PROTECTIVE IRRIGATION WORKS,  
RAJPUTANA.

INSPECTION NOTE

IRRIGATION WORKS AND PROJECTS,  
JHALAWAR STATE.

1905.

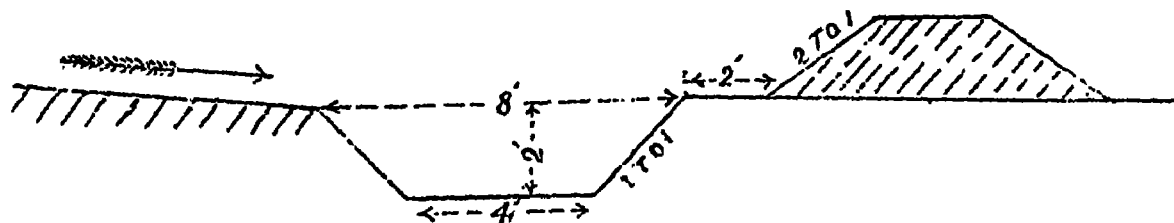
On level ground, a berm of *at least* 5 ft. on either side should be given, and the earth excavated formed into a bank of proper section.

It will be found more economical to do this at once, will save any chance of sides and earth excavated falling back into the channel, and the channel can also be widened later if found necessary.

On side-long ground the earth excavated should be formed into a bank on the *lower side only*; and any surface drainage in the rains will then pass away down the channel.

The earth which has now been thrown up above the channel should be removed, otherwise in the rains it will all be washed back into the channel again, and cause trouble.

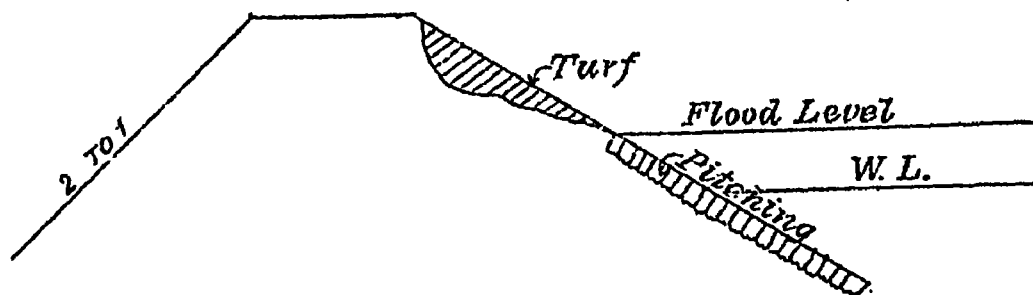
The apron below weir recommended by Consulting Engineer has been made, but later on, when there are funds, I would recommend the weir being placed at the south-east end by the Kishenpura Village, where there is rocky high ground, and the water would spill over this without doing harm, into the nullah below.

The dam would be extended on the north-west beyond the present weir till high ground is reached. At present the flood water damages the fields below at this end, and if the weir was altered I understand 25 bighas extra could be irrigated.

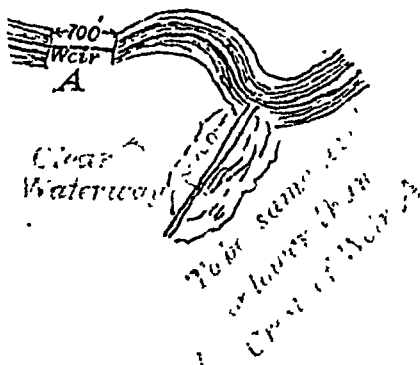
With regard to para. (8) the flood water has cut away the surface earth at the south weir down to rock, lowering the weir level to nearly 5 ft.

The water is cutting away the toe of the rear slope of the dam and a large area of good culturable land, in finding its way down to the nullah.

The Assistant Engineer proposes continuing the dam at this end on to high ground, and closing this weir altogether.

If the south weir is closed altogether—and I think it certainly should be done—levels must be taken to see that the ridge dividing the two catchments of the Mandliakheri tank is not higher than crest of the north weir. If it is, the ridge must be cut down to this level for 700 ft. in

length, to give a clear water passage for the flood water to the weir, otherwise the water will head up and there will be danger to the dam.

**Semli Tank**  
(Site No. 10.)

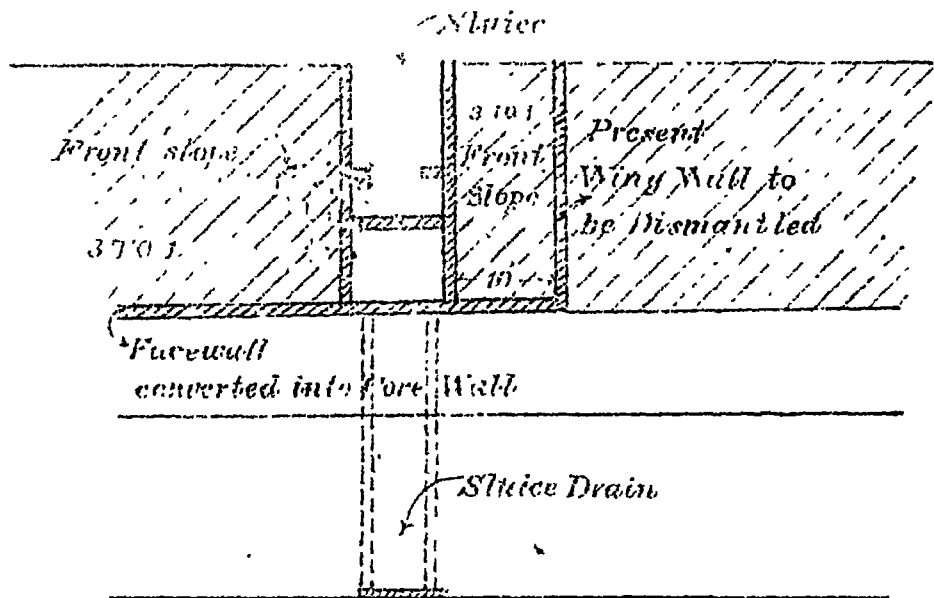
It would therefore seem well worth raising the weir and dam and building a sluice.

The Assistant Engineer should check the present capacity, and take contours of the basin to find the height the weir should be raised to give the proposed capacity. The maximum flood on 1 square mile is 825 cusecs, and this can be discharged by the 78 ft. weir with 2-ft. head, so crest of dam should be made 5 ft. above new weir level.

The babul trees should be removed and sold, and all roots removed before adding the new earth; and the face-wall might be converted into a core-wall, and to prevent any chance of water creeping round, the sluice should be fixed 10 ft. from the wing-wall, which should be dismantled as it is all cracked. The sketch shows what is suggested.

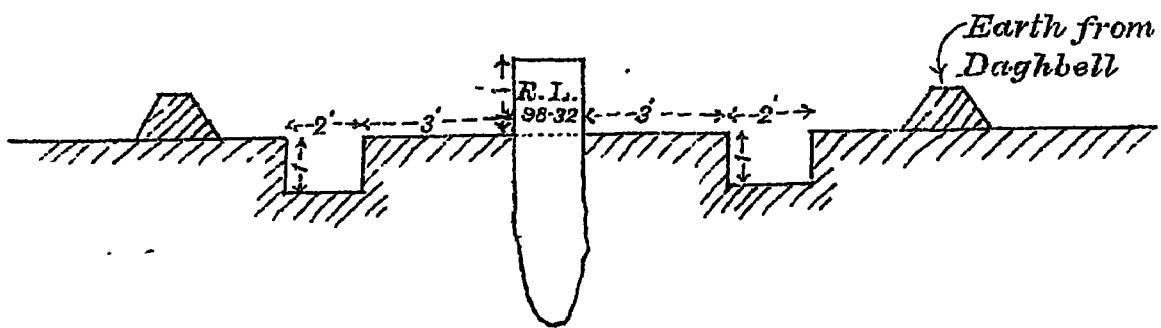
From topographical Survey the catchment is 7.5 square miles ; from this the maximum discharge (Dickens Formula) is 3.737 cusecs. and the length of weir required to discharge this with 2-ft. head is 375 ft.

The dam is proposed to be 6 ft. wide at top, with front slope  $2\frac{1}{2}$  to 1 and rear slope 2 to 1. Crest 5 ft. above weir level. The front slope should be made 3 to 1. The size of Sluice and Irrigation Channel required is not given, these should be worked out always by—

(a) Finding the discharge per second required to empty the tank in four months (Rabi Irrigation season) ;

(b) And as water is required simultaneously at first for Irrigation. the discharge required per second to give a first watering of 6 inches in 30 days of 12 hours' flow to the whole area for which there is sufficient water.

SECTION

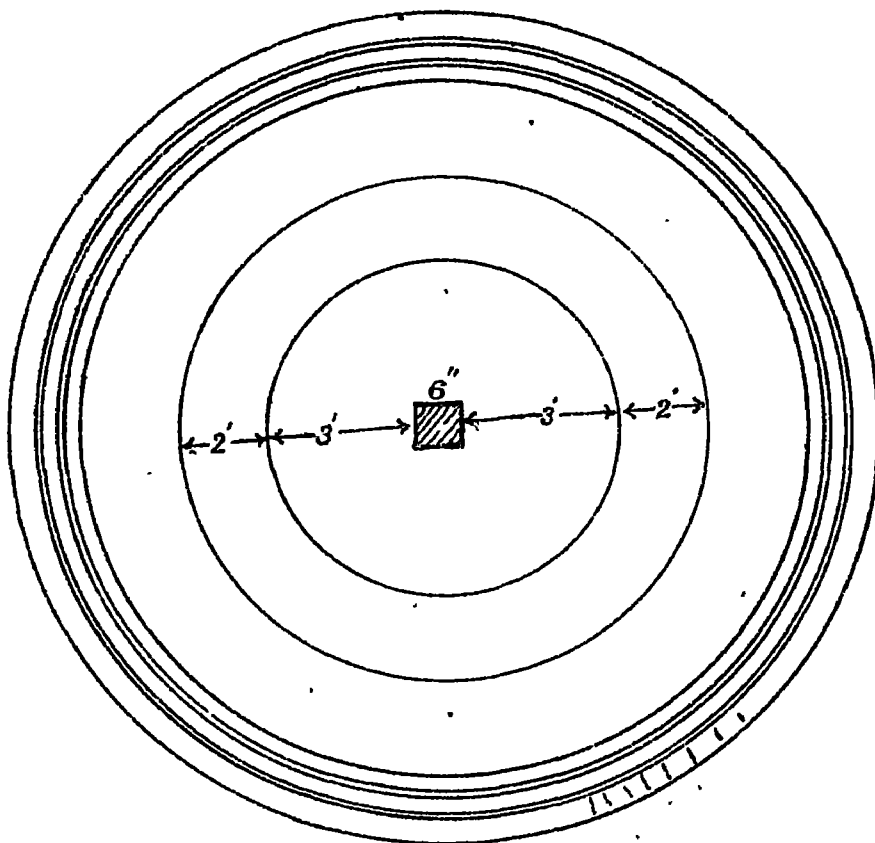
- (a) The line of dam clearly daghbelled from end to end, 1 ft. wide and 1 ft. deep.
- (b) Permanent bench marks erected, cut out of the rock in river beds or where rock occurs, along the line of dam, showing the bed level of nullah, and every 5 ft. rise, also at any point where the line changes. Also at ends of the base line and cross-section lines of survey.

These bench marks should be stones set on edge, embedded  $1\frac{1}{2}$  in the ground, with a circular daghbell all round as per sketch, the number and reduced level, corresponding with Field Book, being marked on the stone.

**Ratanpura.**  
(Site No. 19).

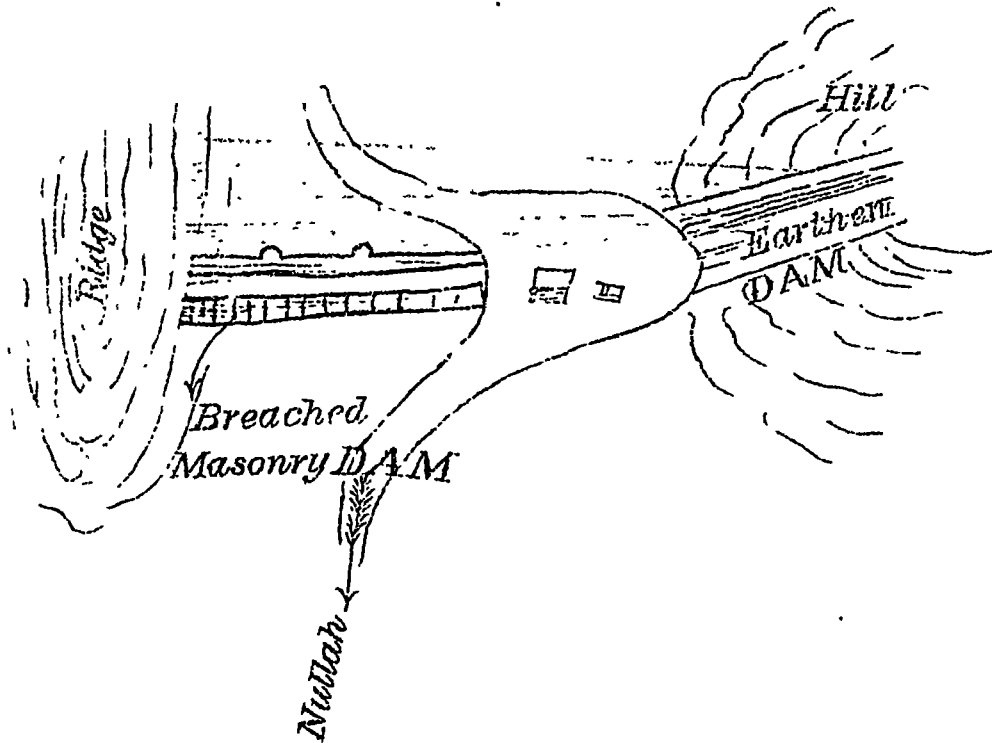
But the catchment area has been over estimated, as from the Topographical Survey Map it is only half a square mile.

This reduces the water available for storage to 7 m. c. ft. even if we allow 20 per cent. of rainfall, as the catchment is hilly. This will therefore reduce the capacity of the tank, and the surveys should be carefully checked and the water-spread and capacity at each 5 ft. contour carefully worked out.

The weir level should be kept at the lowest point of the ridge towards Ratanpura village, and the water allowed to spill over here, even should this give a greater capacity than required; the maximum discharge on the half square mile catchment is 490 cusecs, and as this gap in the ridge is about 400 ft. long the water is not likely to cut it away. The line proposed by the Assistant Engineer for the earthen dam across the nullah may be accepted, but care must be taken that the new dam is entirely separated from the old dam; and the space in rear between should be filled up to the top of the masonry wall to prevent a pool of water being held up between, which would damage the dam.

The line of dam was not daghbelled out, nor were there any permanent bench marks, not even one on the masonry dam, so that it is impossible to check the surveys made by Sub-overseer Muntaz Ali. The directions given in para. 12 should always be carried out.

The Plans made are difficult to estimate from, as the cross sections are drawn to far too small a scale.

They should always be drawn to a natural scale 10 ft. = 1 inch. Directions on this point and a printed copy of one of the projects prepared in this office have been given to the Assistant Engineer as a guide for the future.
